The Harman Kardon Model hk570i

AM/FM/Stereo FM Solid State Receiver

Supplementary Manual

SERVICE BULLETIN #1010 - DECEMBER 4, 1981

SUBJECT: TURN ON TRANSIENT - MODEL hk5701

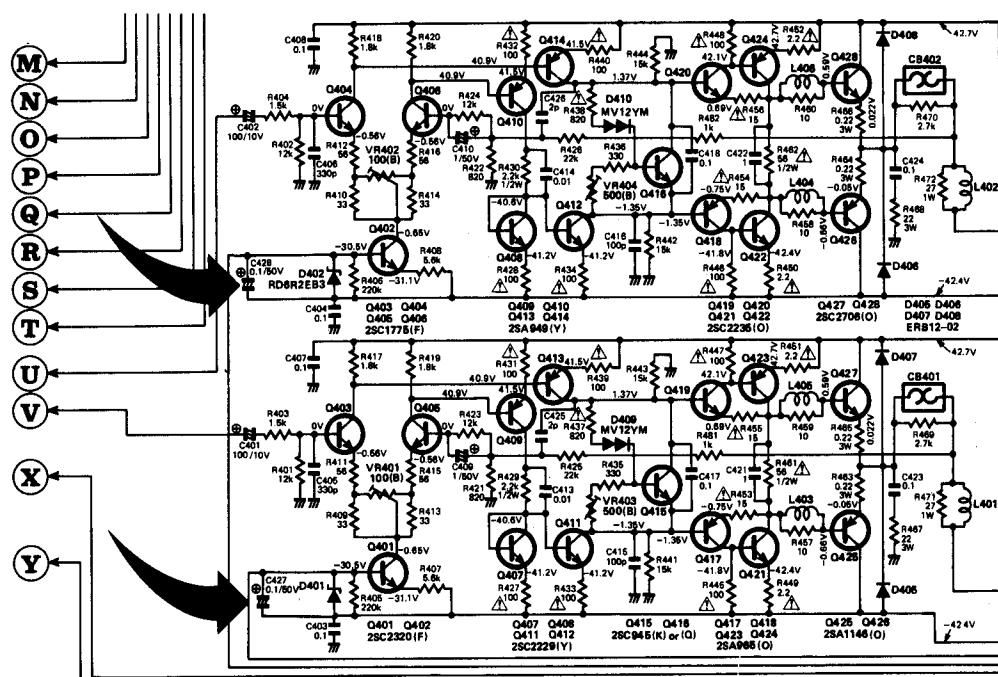
When efficient loudspeakers are connected to the hk5701, there is the possibility that a slight pop noise is heard at the moment the unit is switched ON.

In order to reduce this small "turn on transient" it is recommended to solder on the bottom of the power amplifier PC Board two capacitors across the zener diodes D401 and D402. The positive side of these capacitors shall be connected to the base of Q401 respectively Q402.

The rating of these capacitors shall be 0.1 microfarad/50V.

This modification applies only to units with serial number 08501 and lower.
